## PLANNING COMMISSION MEETING

**RE: Ginko Self Storage -Final Site Plan/Final Engineering Plan Review-3<sup>rd</sup> Review  
Stormwater Maintenance Agreement Review-1<sup>st</sup> Review**

## Revised Final Site Plan Review for Special Land Use for White Lake Charter Township, Michigan

# GINKO SELF STORAGE

DRAWING NUMBER:  
**C-6.0**

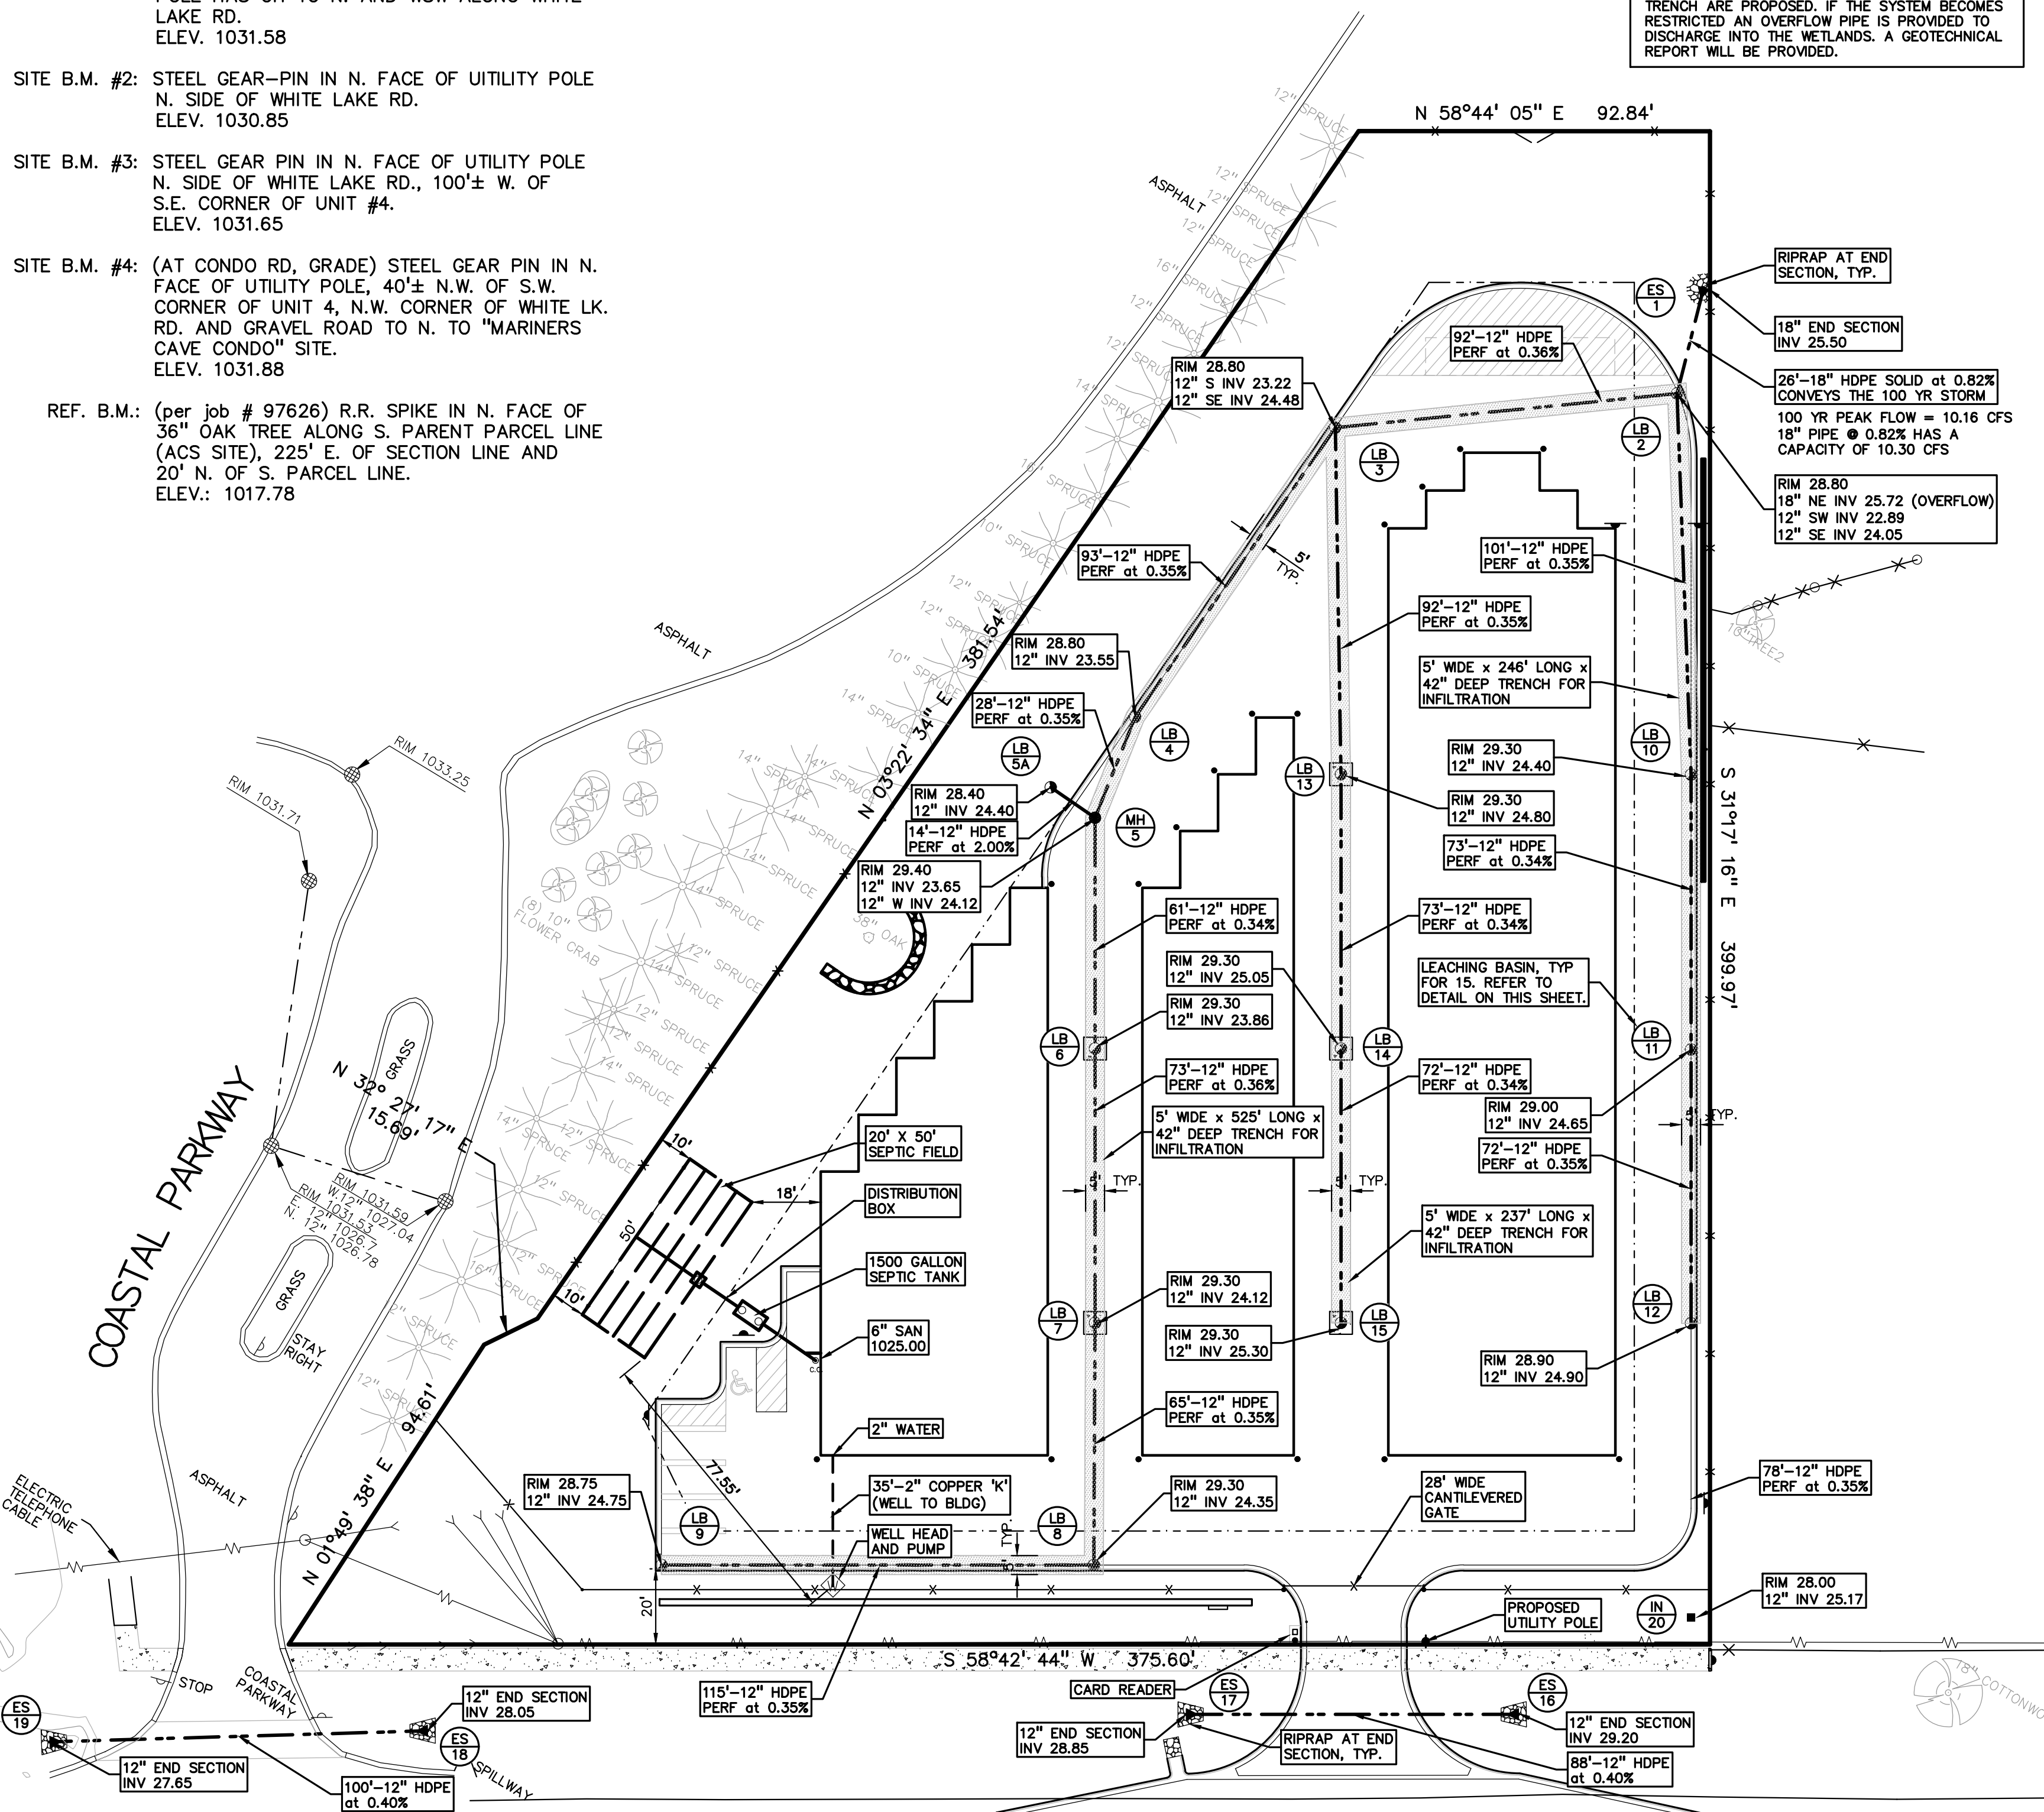
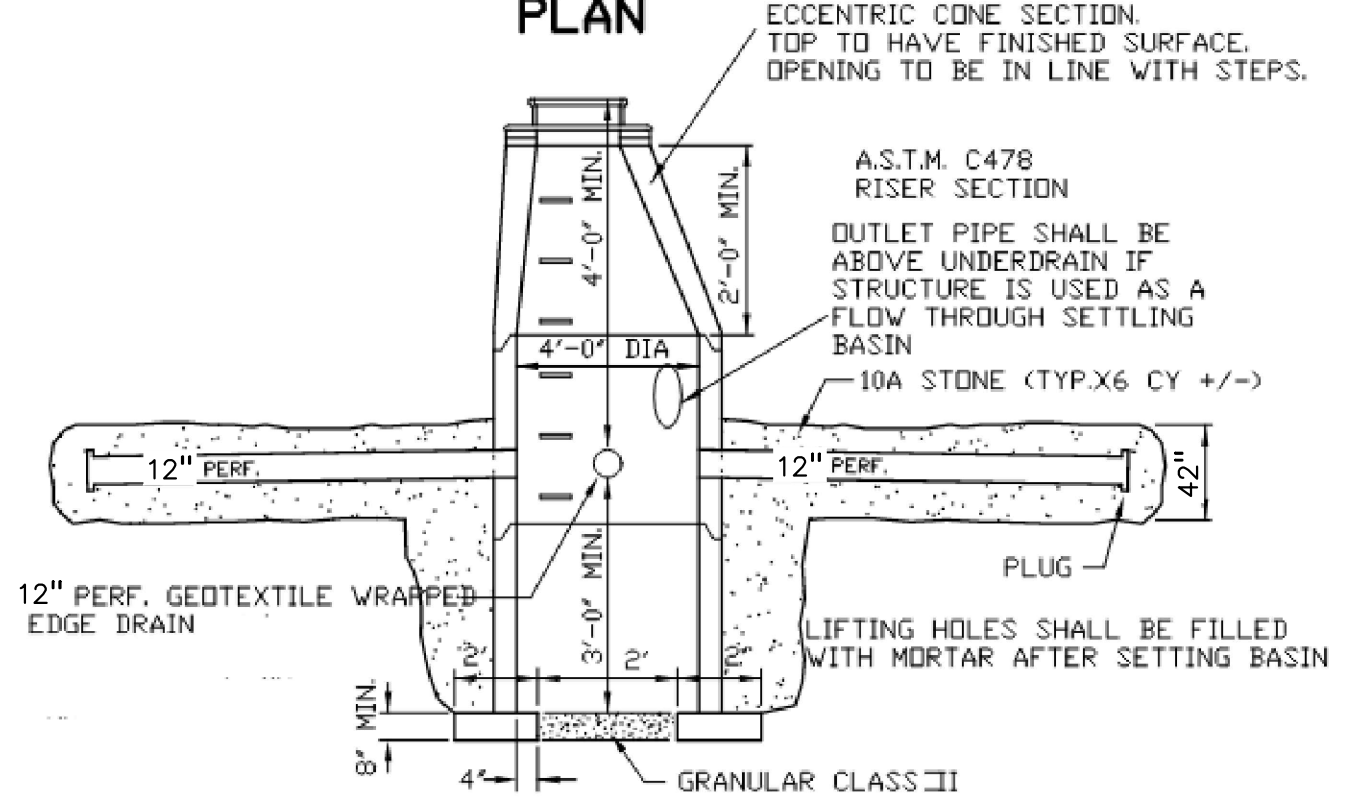
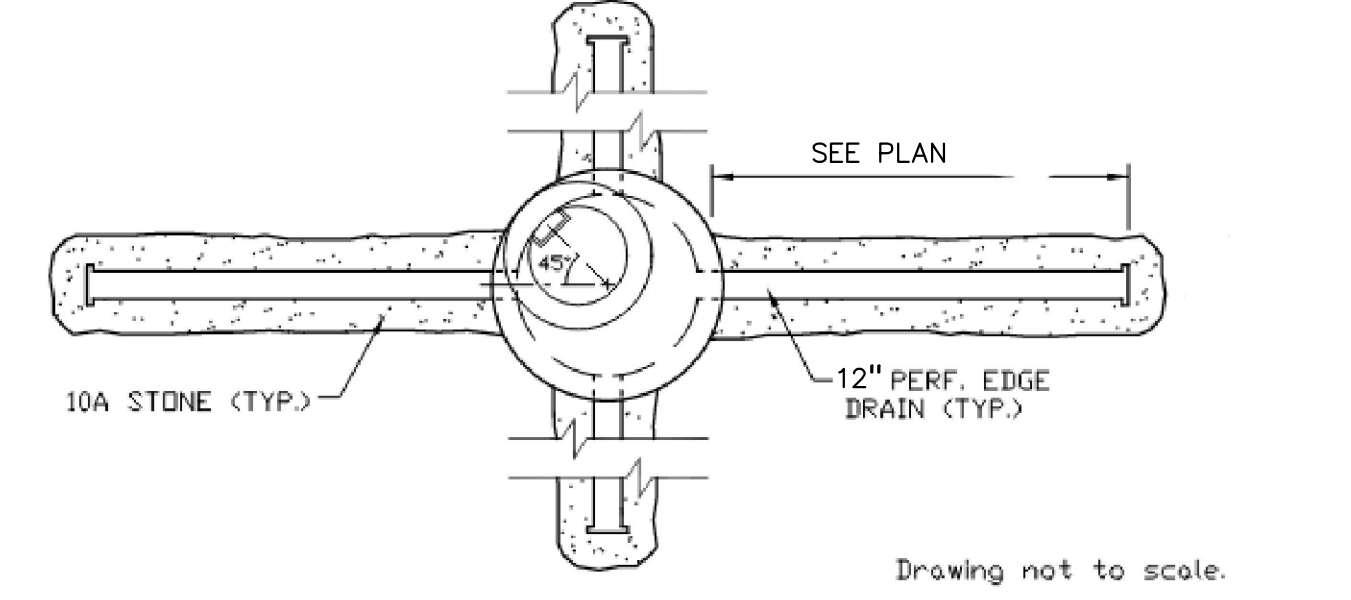
4. *Sheet C-6.0- Detention/Infiltration Calculations- Average Infiltration Area ( $A_t$ ) – LF of storm pipe is incorrect; It should be 1008 LF. We also calculate 1010 LF based on given footages on Sheet C-6.0. Please verify. **Comment addressed. LF of storm pipe has been corrected.***
5. *Sheet C-7.0- The following rim structures do not match those shown on Sheet C-6.0: LB2, LB3, LB4, MH5, and LB17. **Comment addressed. Rim elevations now match between sheets.***
6. *Sheet C-7.0- LB8-Rim elevation does not match Sheets C-4.0 and C-6.0. **Comment addressed. Rim elevation now matches.***
7. *Sheet C-7.0-Add 12" INV.23.65 to MH5. **Comment addressed. Invert has been added.***

Sheet C-6.0 provides preliminary utility layout and information. The site will utilize well pump and septic fields. A note on the Sheet states *“No adequate storm sewer, open ditch or road ditch is available for storm sewer disposal. Since soil composition is optimum and groundwater table is suitable for percolation, Township standard leaching basins and stone trench are proposed. If the system becomes restricted an overflow pipe is provided to discharge into the wetlands. A geotechnical report will be provided.”* We defer to the Township Engineer to determine if this proposal is adequate.

Sheet C-6.0 also provides septic calculations as well as shows the location of the septic field and well pump. A note indicates the site will connect to public water should it become available at the property.
